# Flood County Park Landscape Plan

Final Revised Environmental Impact Report/  
Response to Comments Document

*prepared by*  
**County of San Mateo Parks Department**  
455 County Center, Fourth Floor  
Redwood City, California 94063  
Contact: Sam Herzberg, Senior Planner

**October 2019**

**Figure 5 Proposed Parking Map**

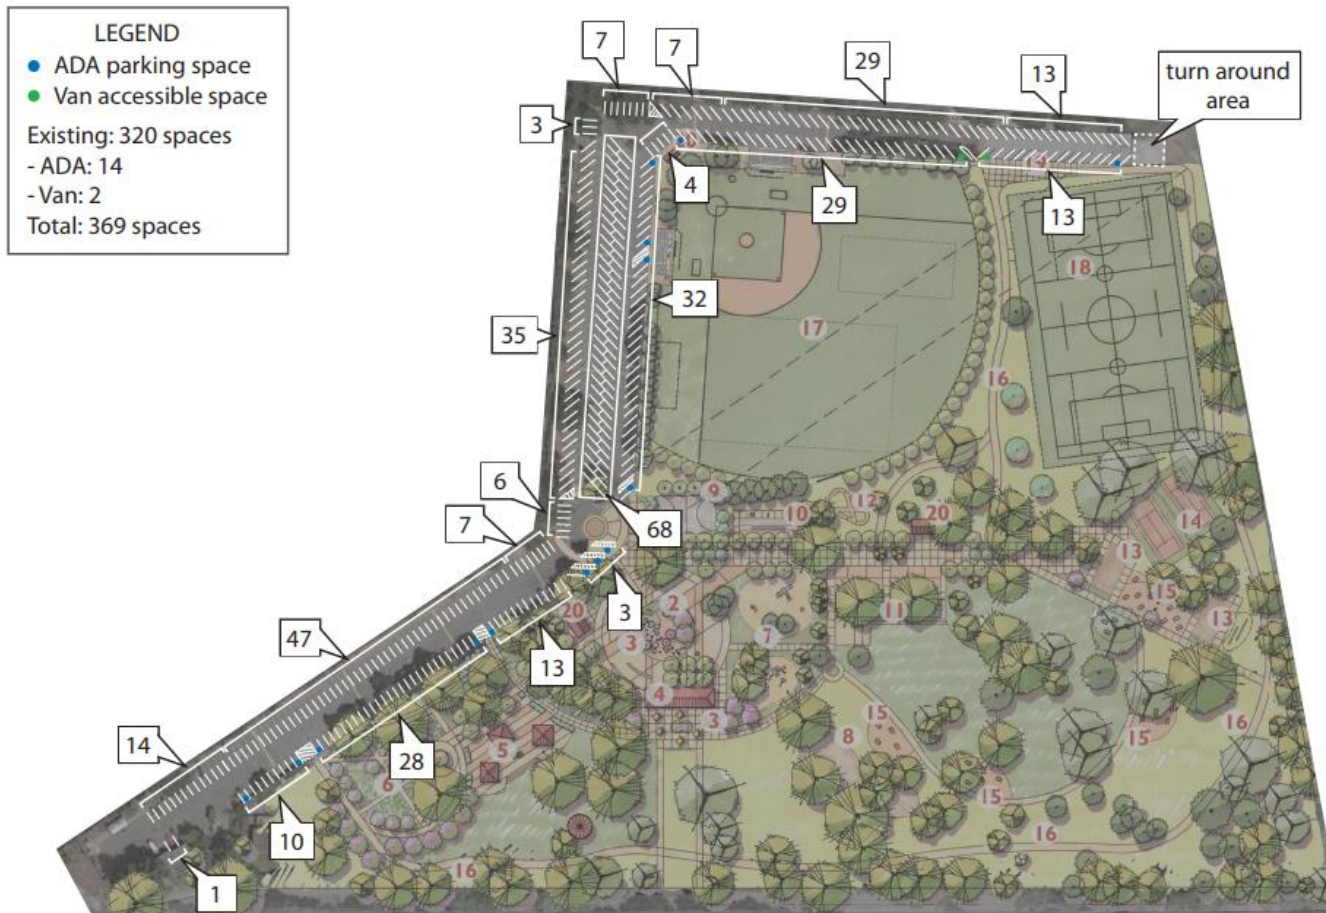
- *The Draft EIR's analysis of parking demand generated by the Landscape Plan is inadequate because it relies on inappropriate data and does not account for peak use of the park.*

A second parking count was completed at Flood Park on October 2, 2019 to confirm the number of parking spaces at Flood Park. The revised count identified a total of 320 existing parking spaces at Flood Park. As discussed on page 120 of the Draft Revised EIR the anticipated maximum parking demand during peak summer days under the Landscape Plan is 344 parking spaces. Therefore, there would be a deficient of 24 parking spaces. To account for the deficient in parking spaces the Landscape Plan has been revised to include additional 49 parking spaces at Flood Park. With the additional 49 parking spaces there would be a total of 369 parking spaces at Flood Park, which would exceed the peak parking demand by 25 parking spaces. The Final Revised EIR has been updated to include the following:

The Landscape Plan would not involve changes to parking and access, except for a new drop-off area on-site and stripping for an addition of 49 parking spaces on already paved and gravel surfaces. Flood County Park's existing vehicular access from Bay Road, via the entrance gate at the southwest corner of the park, would be retained, as would the existing asphalt parking lot on the western edge of the site. Pedestrians also would retain access to the park through entrances gaps in a chain-link fence along Bay Road and at the eastern gate from Iris Lane. An additional 26 parking spaces and a turnaround area would be added to the site of the existing pétanque court, as shown in Figure 4 and Figure 5, Proposed Parking Map. New parking stall locations have been identified throughout the site in existing paved areas and include the following: one parking stall near the existing pay station; two parking stalls in the island near the eastward turn near the ballfield; one stall in the island behind the ranger residence; one stall in the island on the south side of the eastward turn; seven stalls in the approximately 60 foot space and four stalls in the approximately 36 foot space before the pétanque court; and seven stalls by converting ADA van parking stalls to ADA car parking stalls . Therefore, an additional 23 stalls stripped outside of the pétanque court and 26 stalls stripped within the pétanque court would add a total of 49 new parking spaces at Flood Park. Please see Figure 5 for a layout of all 369 parking spaces.

**Figure 5 Proposed Parking Map**

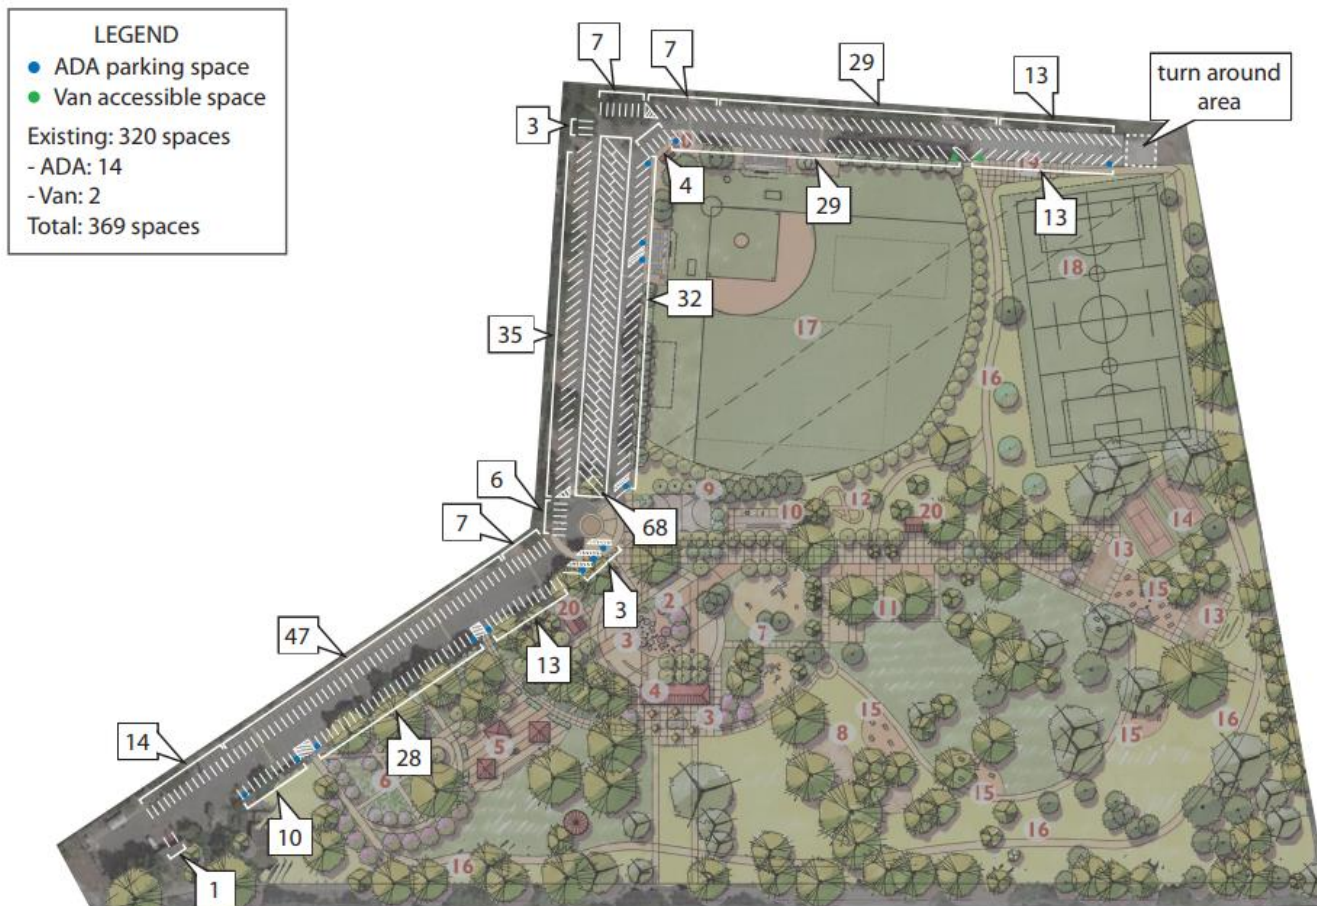
**The EIR states there are 375 parking spaces. This is not correct. There are 330 spaces.** Please confirm this count.

The anticipated typical peak parking demand for the proposed project is 344 parking spaces. The project would add an additional 49 parking spaces at the park for a total of 369 parking spaces. Available parking would exceed the projected demand of 344 parking spaces by 25 parking spaces. Therefore, the on-site parking lot would have sufficient capacity to accommodate parking demand except on rare occasions, such as very large scheduled events. In addition, Mitigation Measure T-6 would inform park visitors of on-street parking restrictions, require the County to coordinate with the City of Menlo Park to reduce parking in adjacent neighborhoods, and encourage targeted enforcement of on-street parking.
